Planning Commission Staff Report

Project Type:	7 th Partial Amended Site Development Plan
Meeting Date:	November 25, 2013
From:	Jessica Henry Project Planner
Location:	Northwest corner of Olive Boulevard and Arrowhead Estates Lane (15201 Olive Boulevard)
Applicant:	Friendship Village of West County
Description:	<u>Friendship Village of West County (15201 Olive Boulevard):</u> 7 th Partial Amended Site Development Plan, Amended Landscape Plan, Amended Lighting Plan, Architectural Elevations and an Architect's Statement of Design for a 34.5 acre tract of land zoned "R4" Residence District with a "CUP" Conditional Use Permit at the northwest corner of Olive Boulevard and Arrowhead Estates Lane (17S320445).

7th AMENDED (Partial) SITE DEVELOPMENT PLAN FRIENDSHIP VILLAGE OF CHESTERFIELD

6th ASDP— Approved Metal Halide Light Fixture

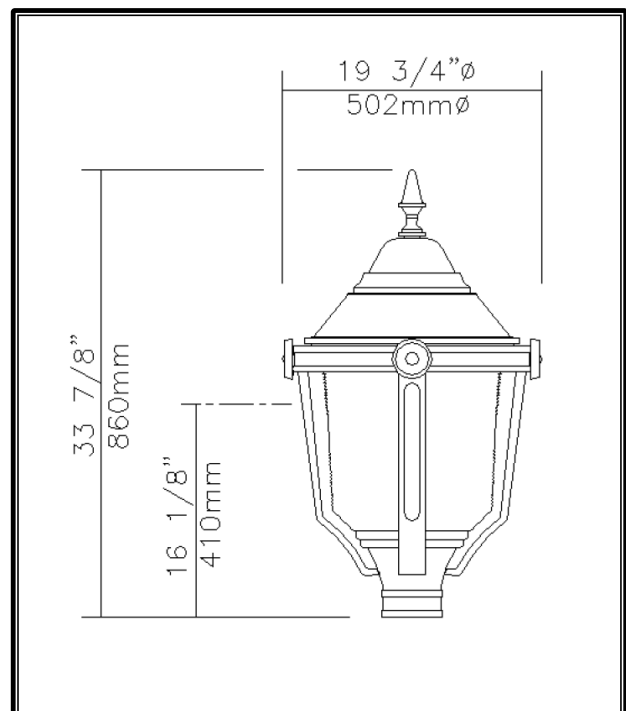
The request is for approval of eighteen (18) metal halide post light fixtures in conjunction with a modification to the location of a sidewalk. A Lighting Plan has been submitted with light fixtures that provide lighting for the internal roadways in the development in addition to fixtures for the pedestrian areas. The change request is only for the eighteen (18) metal halide post light fixtures located along the internal roadways and parking areas; all other fixtures will remain as approved on the 6th Partial Amended Site Development Plan. The eighteen (18) fixtures are decorative and are not shielded. City of Chesterfield Ordinance 2228 provides the following exemption for Fixture Design:

The proposed lighting is all within the confines of the site and no light trespass will occur. Additionally, there is no change in light levels as approved on the 6th Partial Amended Site Development Plan.

City of Chesterfield CUP #36 restricts light standards to a height of sixteen feet. Although the light post shown on the lighting cut sheet attached to this report is fifteen feet in height, the post is available at a thirteen (13) foot height as a special order, which the applicant proposes to use as noted on the letter provided. A manufacturer cut sheet is not available for the special order height; however, the motion to approve includes the condition that the thirteen (13) foot special order light post be used in order to comply with CUP # 36.

- 1) "I move to approve (or deny) the 7th Partial Amended Site Development Plan, Amended Landscape Plan, and Amended Lighting Plan for Friendship Village of West County with the condition that the light standards shall not exceed sixteen (16) feet in height when measured from the bottom of the light post to the top of the light fixture..." (Conditions may be added, eliminated, altered or modified)

7th ASDP— Sidewalk Location and Courtyard Area

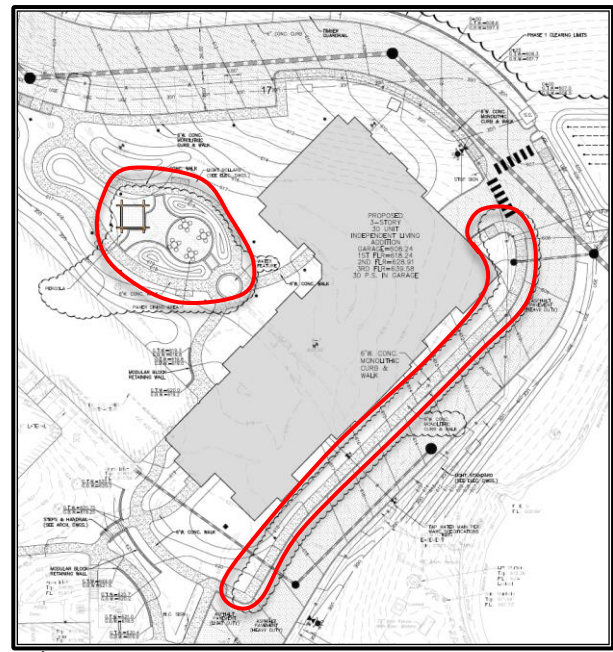
The changes proposed on the 7th Partial Amended Site Development Plan maintain pedestrian connections to the other buildings on the site and connections to the existing pathways and trails. However, as shown below, one internal sidewalk is being moved from the far side of an internal roadway and is instead placed alongside the building. Additionally, the landscaped entry courtyard and water feature are being expanded and a pergola is being added to the south side of the new addition.
